Access Compliance Report

Public Rights-of-Way

(Island Curb Cuts)

Intersection ID: 10035599	Main Street: REAMES_RD	Cross Street: N/A	Location: N
ADA ID: 3294F97E0FC9	Curb Cut Type: MedianRefuge2	Initial Pass/Fail: Fail	Overall Compliance: No
Codes/Mitigation Info/Possible Solution		Field Measurements/Component Compliance	
Severity Score: 0

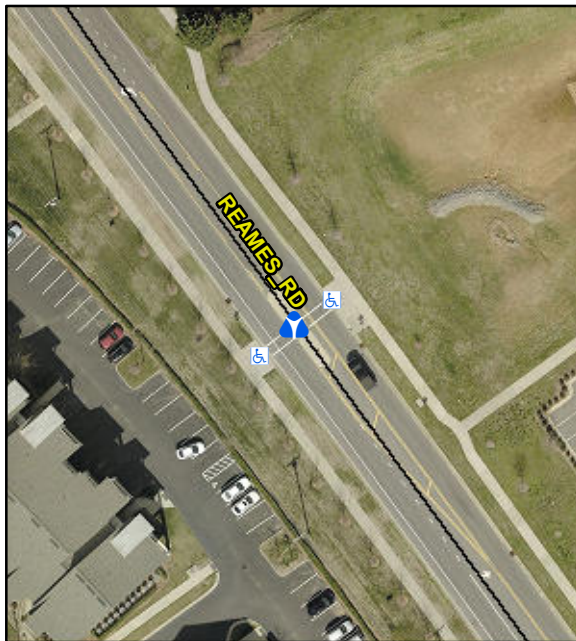
Remove & Replace Entire Refuge.
